SUBJECT: NRC Midland Project, Request for Additional Borings and Existing
Soil Data - Revision No. 1

INCLOSURE 1

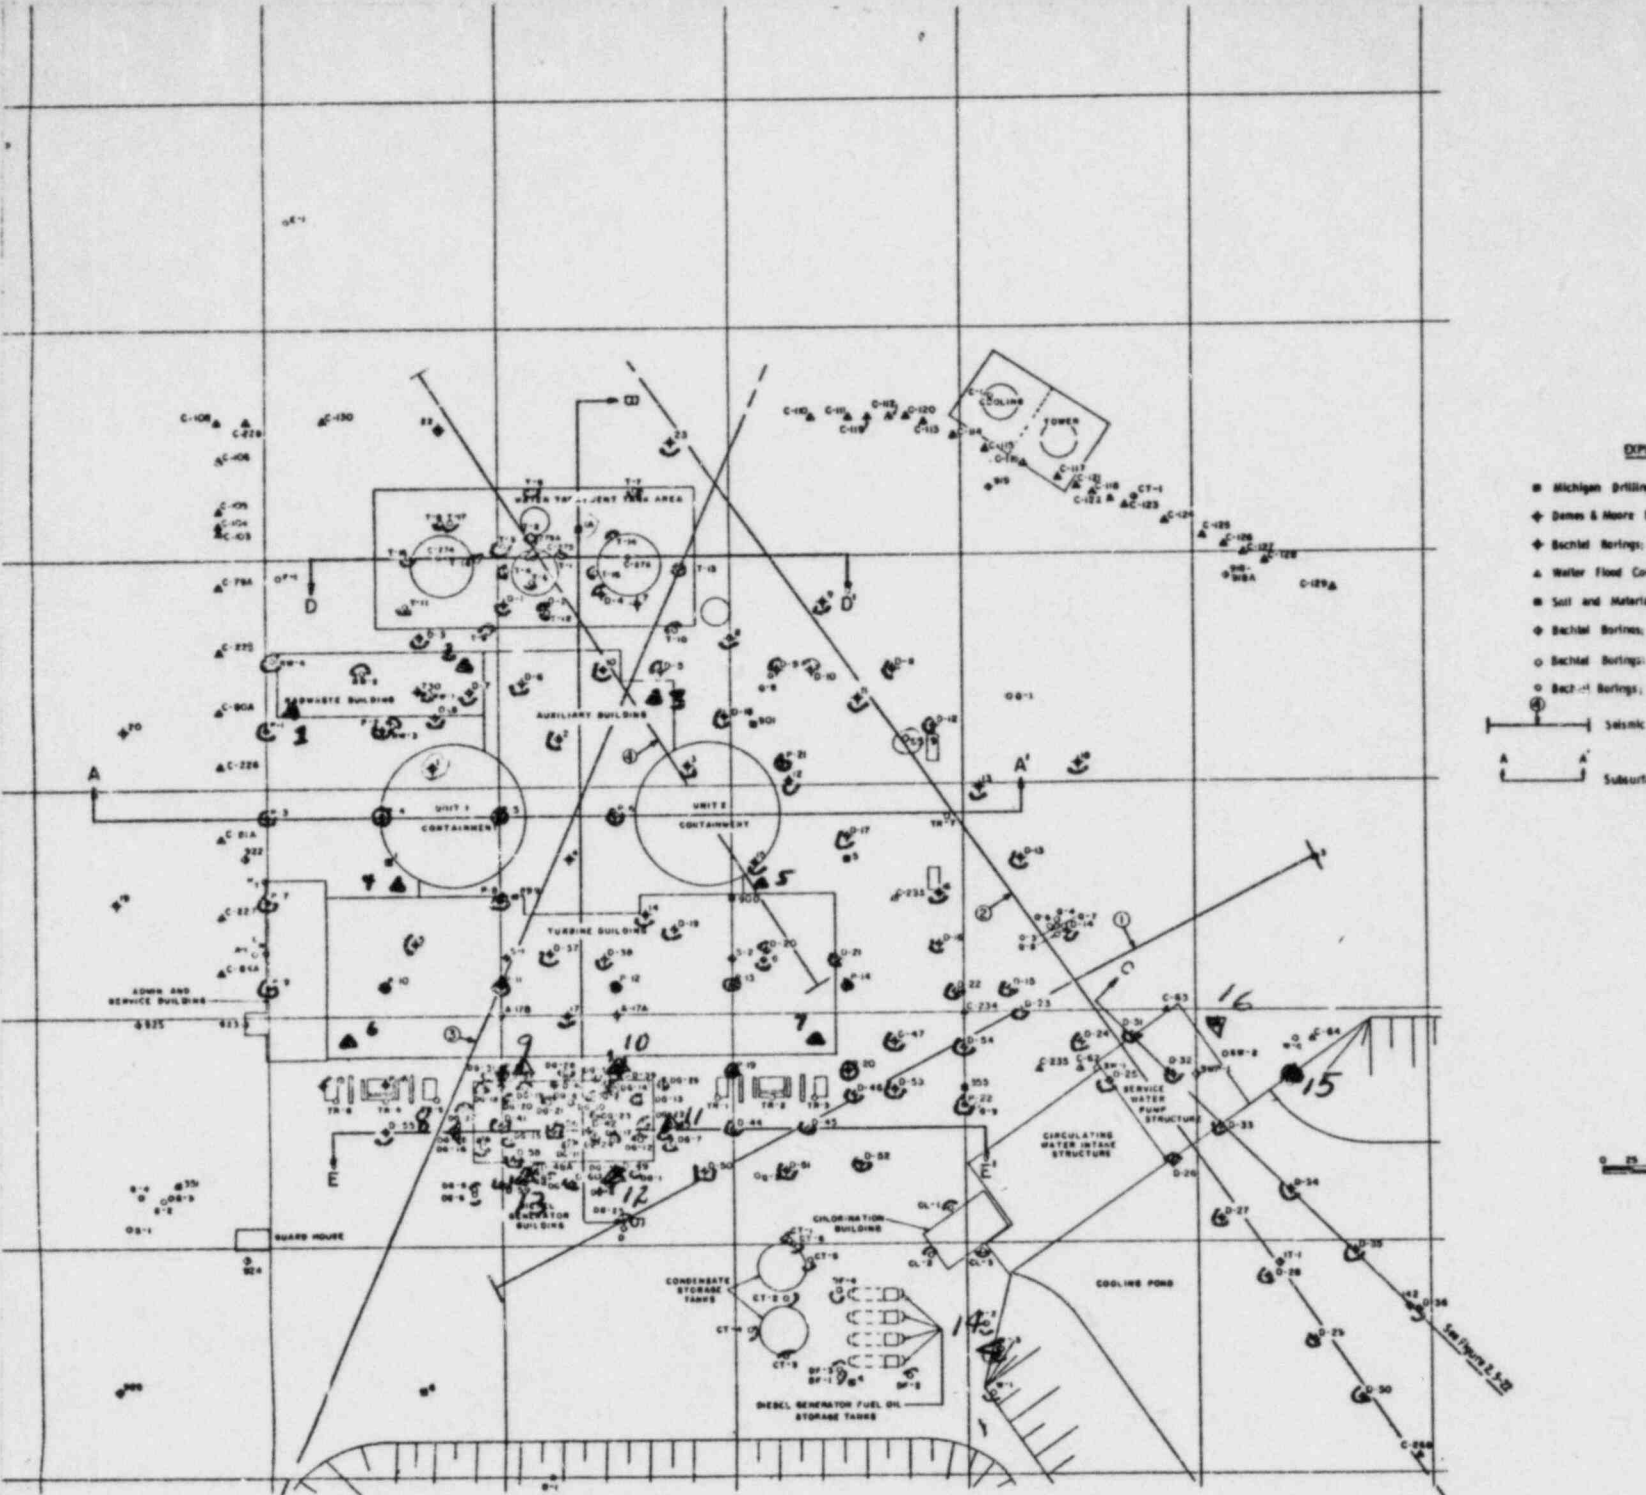
a. Diesel Generator Building - 4-6 holes around the perimeter of the building. Samples of all strata from ground surface into the glacial till (Holes 8-13). Include downhole, crosshole and surface geophysical tests to establish insitu compression and shear moduli for floor response spectra design check mentioned on pg. 18 Q VII-4 of Interim SER.

b. Auxiliary Building - Take two borings around the proposed support piling or caisson for remedial grouting of loose sands and soft clays adjacent to pile or caisson to stiffen piles and adjoining ground against lateral loading. Borings need to penetrate to glacial till. (see attached map for boring locations - Holes 4 & 5.)

c. Service Water Building - A boring (Hole 16) shall be made as indicated on the attached map to and into the glacial till. All samples obtained shall be classified according to the Unified Soil Classification System also consolidation, drained and undrained triaxial compression tests made on cohesive soil samples and direct shears for a loose and dense condition shall be made on all granular soil samples, as specified in paragraph 7B.

d. Plant Area Borings - If feasible some borings should be taken under the Radwaste and Turbine Buildings to determine if unwatered pockets exist or persist. Suggested boring locations would be as indicated on the attached map. Further investigation could be needed after the results of these borings are obtained. No borings presently exist in these areas. The borings should be cased or hollow stem auger borings with drive samples every 2-1/2 feet through the fill. The holes should be converted to dewatering holes or used for piezometers (Holes 1, 2, 3, 6 & 7).

e. The site visit of 27 or 28 February 1980 turned up two differential settlement points on the retaining wall adjacent to the Service Water Pump Structure. Two borings, Holes 14 and 15 as indicated on the attached map shall be taken to investigate this problem. Tests required are consolidation tests, triaxial compression tests, Atterberg limits and gradation tests made on cohesive soils, and direct shear for loose and dense conditions and gradation tests made on granular soils.
